UNITED STATES  
NUCLEAR REGULATORY COMMISSION  
WASHINGTON, D. C. 20555

SUBJECT: CYCLE 7 RELOAD AMENDMENT, SUSQUEHANNA STEAM ELECTRIC STATION,  
UNIT 1 (TAC NO. M82356)

Amendment No. 118  
License No. NPF-14

ATTACHMENT TO LICENSE AMENDMENT NO. 118

MAXIMUM AVERAGE PLANAR LINEAR HEAT  
GENERATION RATE (MAPLHGR) VERSUS  
AVERAGE BUNDLE EXPOSURE  
SNP 9X9 FUEL  
FIGURE 3.2.1-1

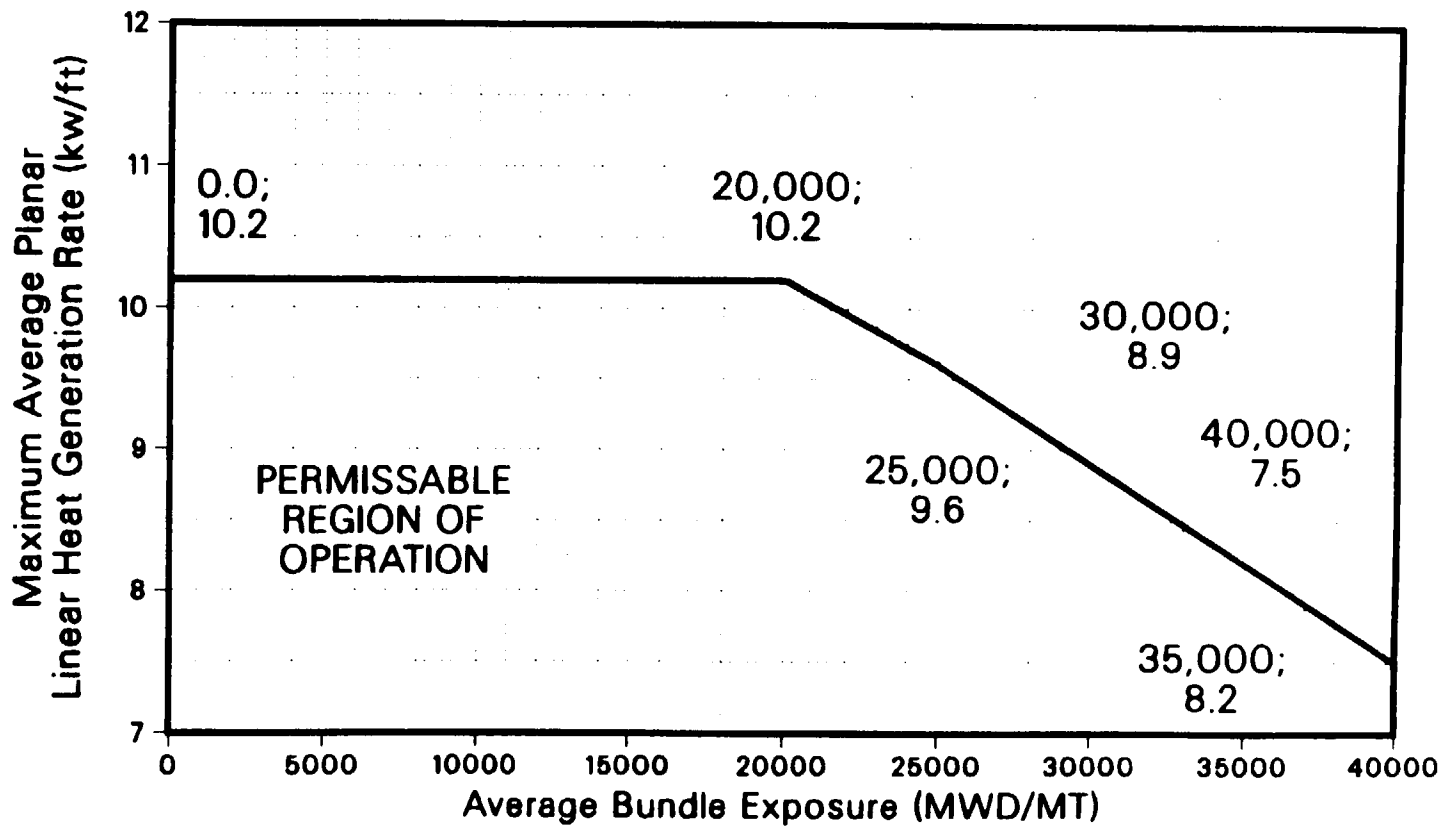
Figure 3.2.1-1 deleted

The LOCA analyses for the Susquehanna plants (Ref. 15) was performed by SNP for a full core of SNP 9x9 fuel and is applicable for the S1C7 residual and reload SNP fuel. These analyses have covered an acceptable range of conditions, have been performed with approved methodology, and the resulting TS MAPLHGR values for the SNP fuel remain acceptable.

LINEAR HEAT GENERATION RATE FOR APRM SETPOINTS  
VERSUS AVERAGE PLANAR EXPOSURE  
SNP FUEL  
FIGURE 3.2.2-1

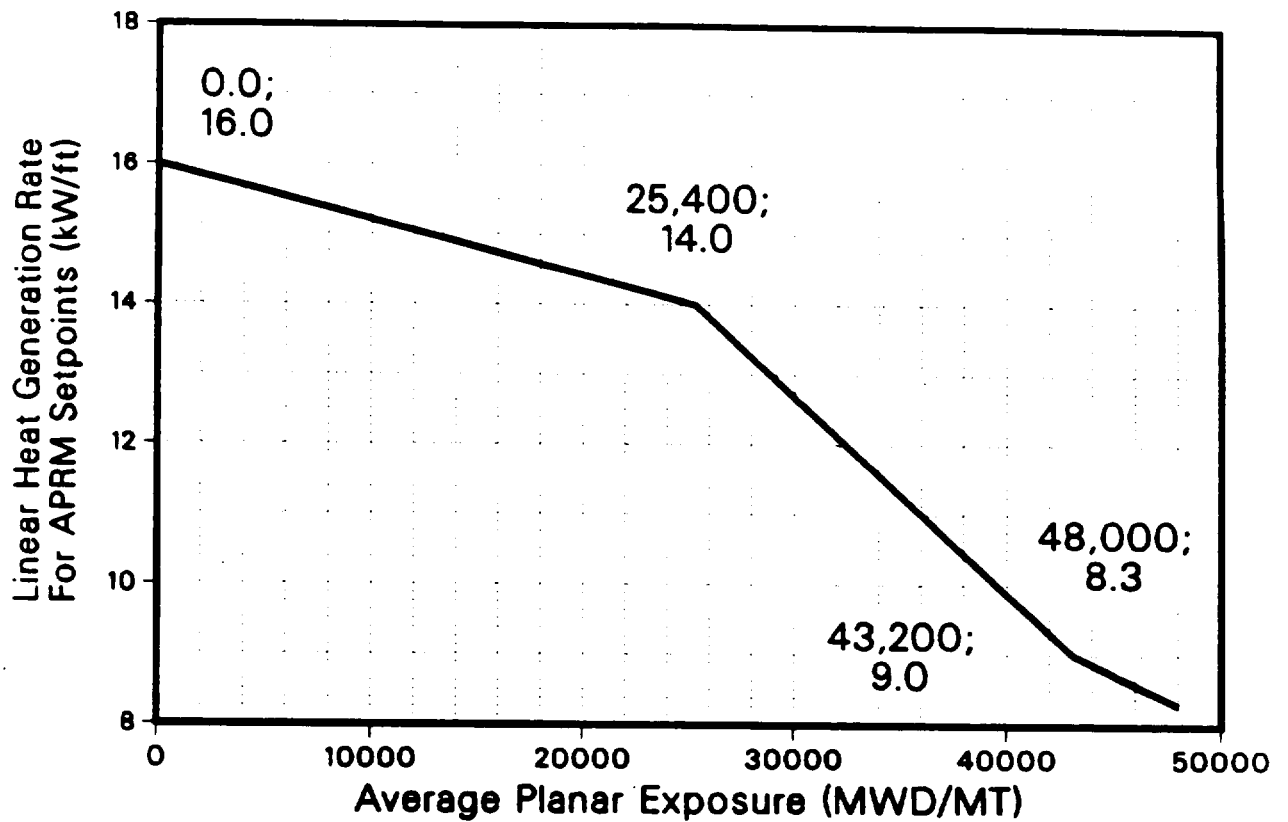
- (2) TS 3/4.2.2 - The changes to this specification are editorial in nature. They update "ANF" references to "SNP", correct words that were inadvertently reversed, and relocate some figure labels. The changes are acceptable.

FLOW DEPENDENT MCPR OPERATING LIMIT  
FIGURE 3.2.3-1

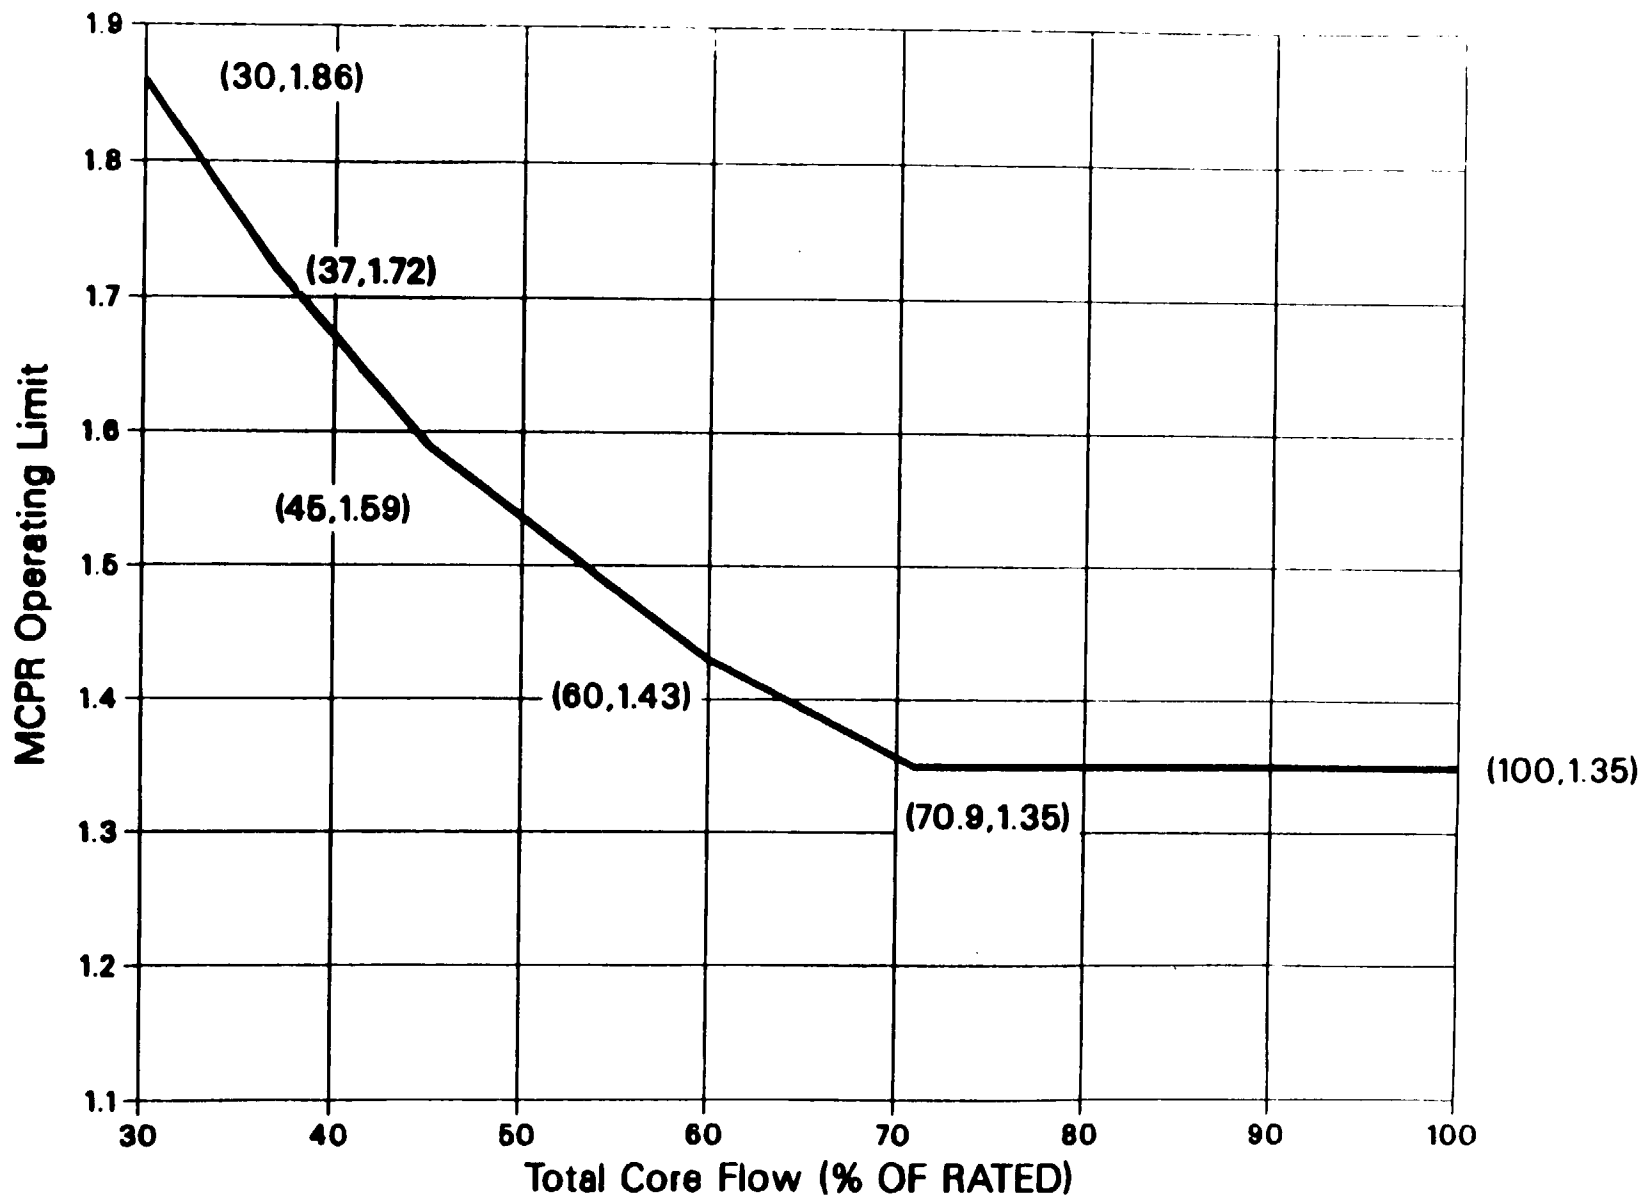
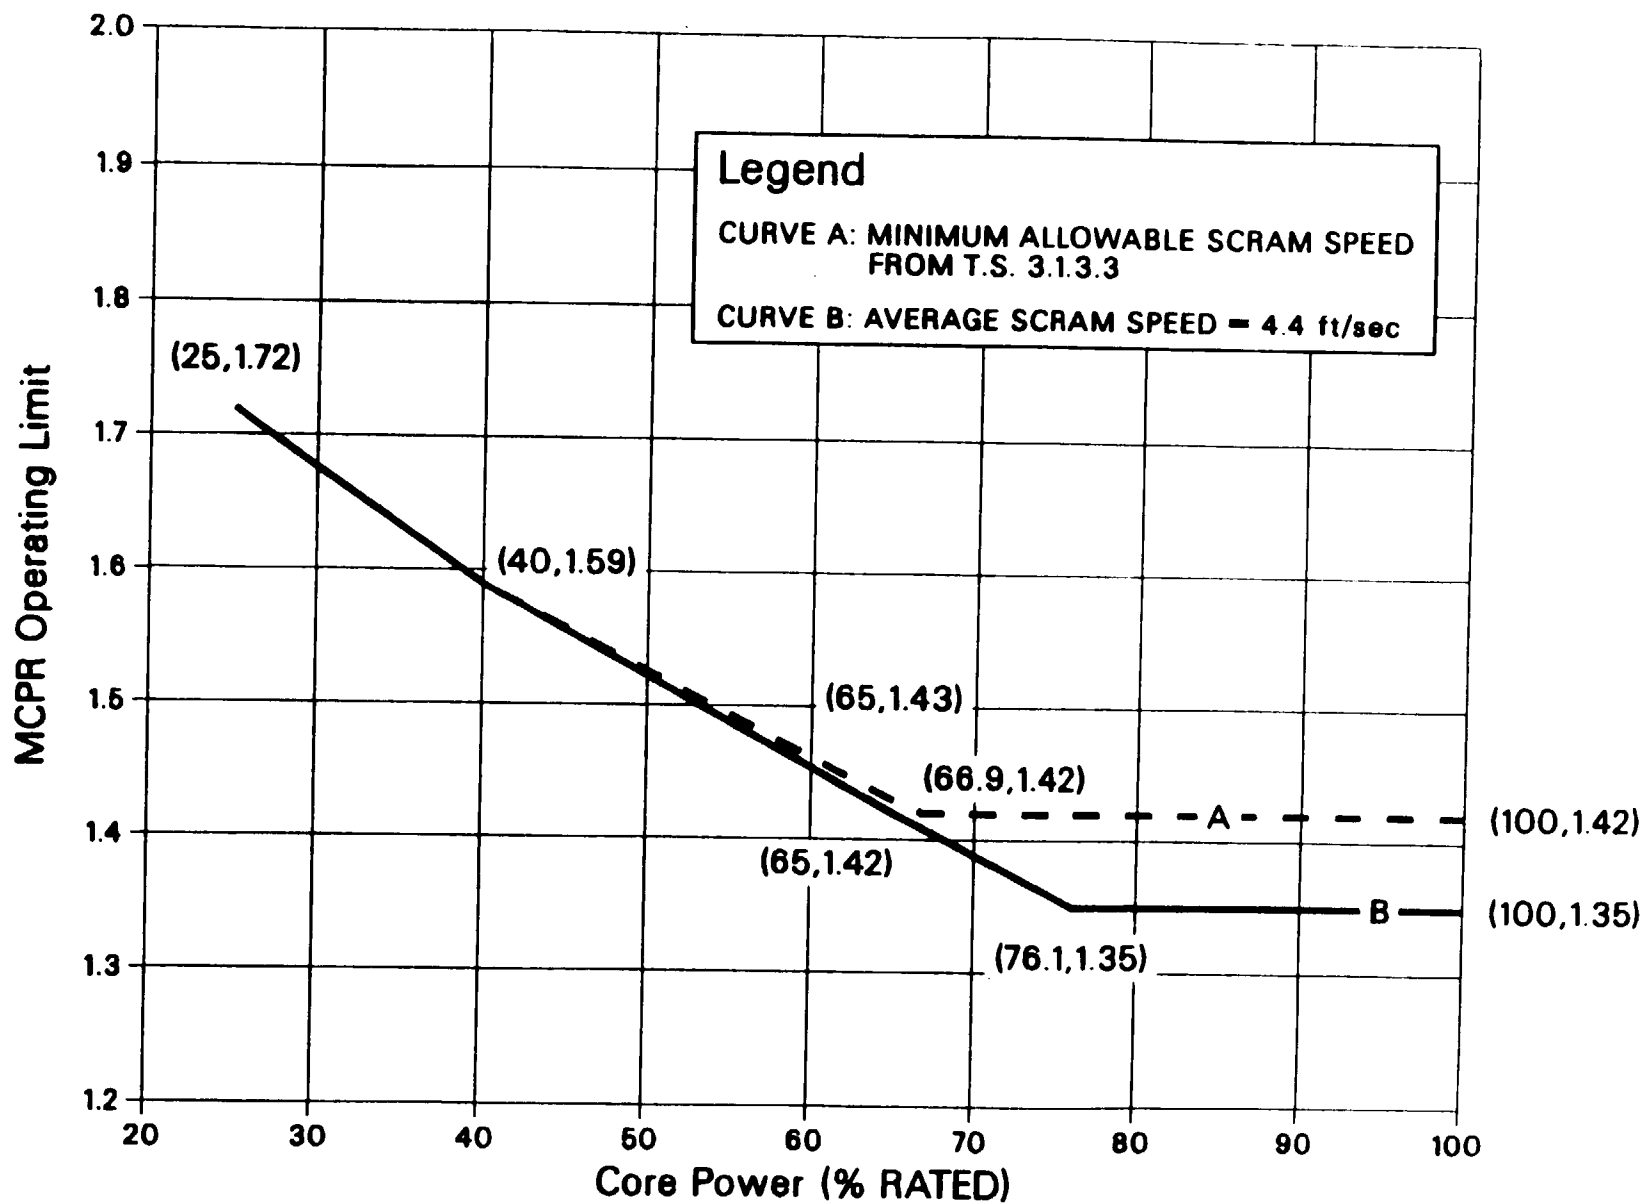
- (3) TS 3/4.2.3 - Figures 3.2.3-1 and -2 are changed to reflect the new calculations of flow and power dependent MCPR operating limits using the parameters of S1C7. In addition, Figures 3.2.3-3 and -4 are added. The limits calculated for Cycle 7 will also be a function of scram speed as discussed in Section 2.5 of this SER. As previously discussed, these analyses have been approved and the changes are acceptable.

LINEAR HEAT GENERATION RATE (LHGR) LIMIT  
VERSUS AVERAGE PLANAR EXPOSURE  
SNP 9X9 FUEL  
FIGURE 3.2.4-1

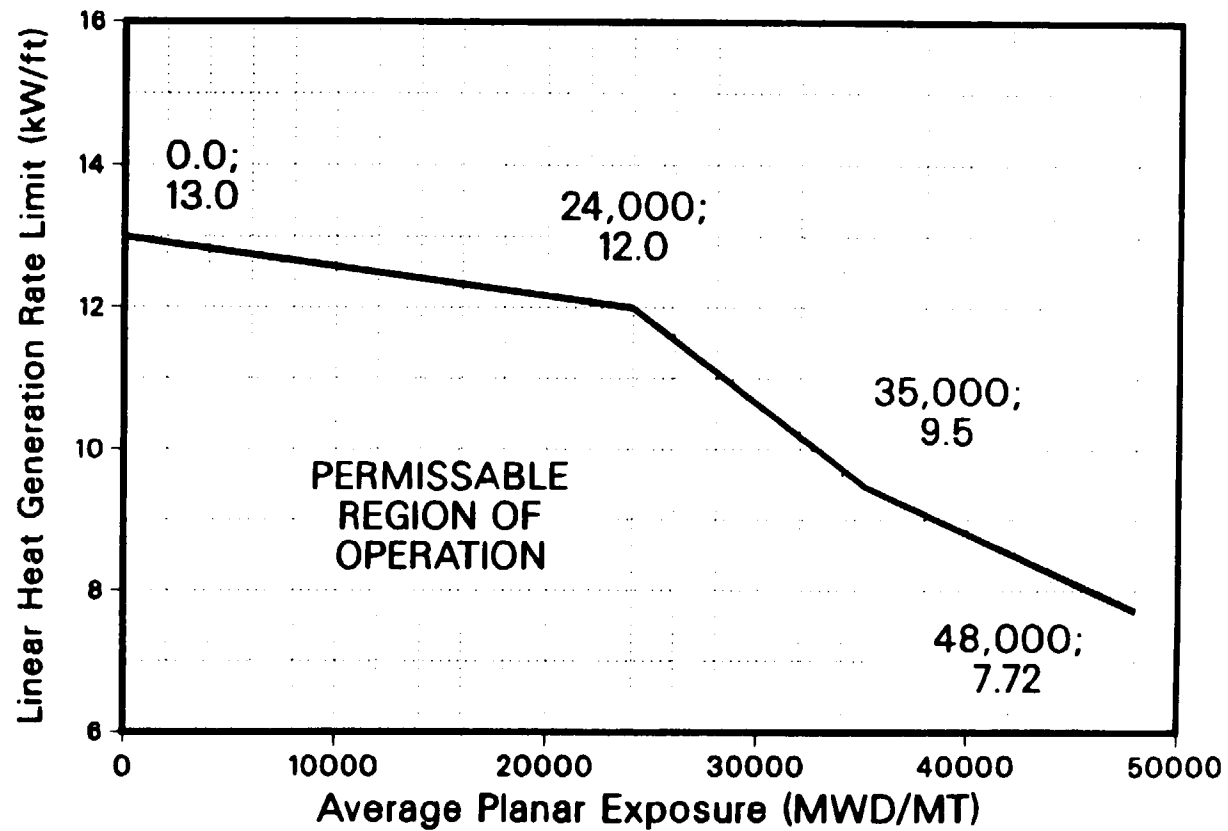
- (4) TS 3/4.2.4 - The changes to this specification are editorial in nature. They delete references to 8x8 fuel, which will not reside in the U1C7 core, and update a reference from "ANF" to "SNP".

A figure of linear heat generation rate (LHGR) limit versus planar exposure (MWD/MTU) is incorporated into the Susquehanna 1 Technical Specifications (TS). This figure was previously approved to reflect the design values which have been reviewed and approved for the SNP 9X9 fuel in connection with the staff's review of XN-NF-85-67(P), Revision 1 (Ref. 10). The staff finds the current LHGR limits for the 9X9 fuel to be applicable for the Cycle 7 fuel and to be acceptable.

**Figure 3.4.1.1.1-1  
THERMAL POWER RESTRICTIONS**

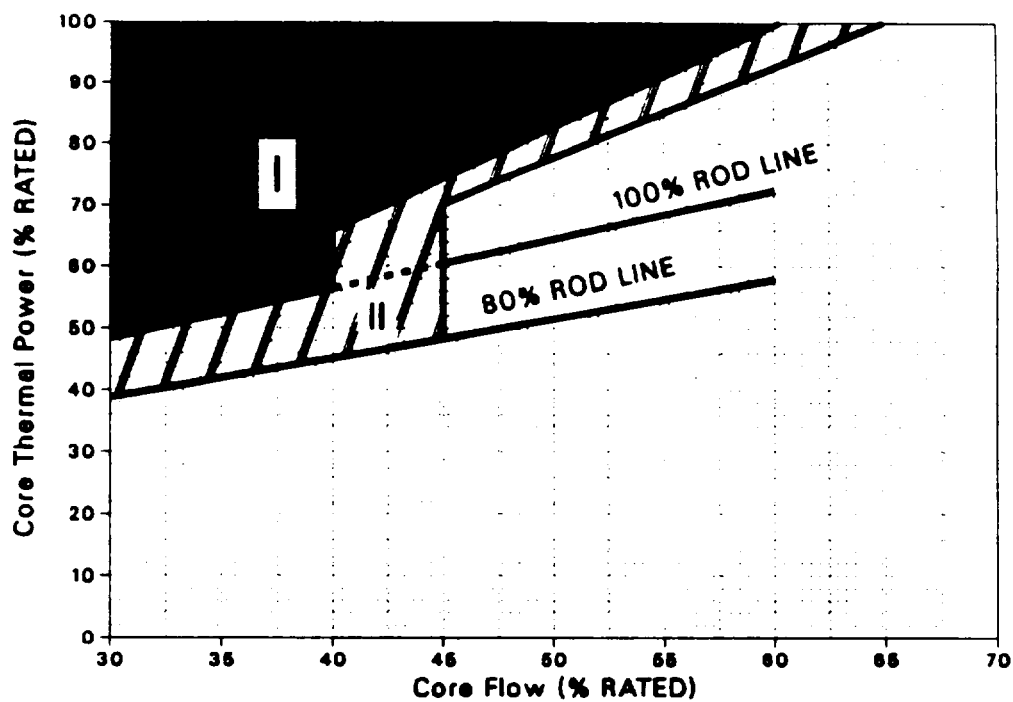
- (5) TS 3/4.4.1 - Figure 3.4.1.1.1-1 is changed to reflect the calculated changes in the regional stability boundaries. In addition, reference to new Figures 3.2.3-3 and -4 for SLO MCPR operating limits is added. These changes are the result of the MCPR SLO analyses discussed in Section 2.6 of this SER and are acceptable.

In response to Bulletin 88-07, Supplement 1 (Ref. 14) on BWR thermal-hydraulic stability, PP&L developed restricted operating regions on the power/flow operating map which were in compliance with the NRC recommendations. Technical Specifications (TS) implementing these regions have been approved by the NRC for Susquehanna 1. Stability tests have been conducted in Susquehanna 2 with various amounts of SNP 9x9 fuel from succeeding reloads, including all 9x9 fuel. These have indicated no significant deterioration of decay ratio. Decay ratios were low in all cases. Calculations similar to those setting up the restrictive boundaries were done for SIC7. TS implementing the changes have been submitted. This review concludes that the analyses are suitable and the changes to the TS are acceptable.
